Ryan Service Bulletin

Product Type: 36" TOW Lawnaire

Bulletin No: C-025-06

544860 Tire Assembly

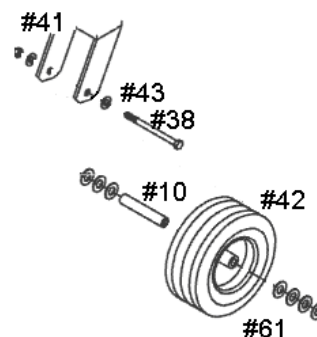
ISSUE:

Tire may rub Yoke.

Change tire assembly with hardware.

53-186 Wheel/Tire (Item 42)

50-062 Spacer (Item 10)

64123-130 Bolt (Item 38)

64163-61 Washer (Item 61)

64163-16 Washer (Item 43)

64229-03 Lock nut (Item 41)
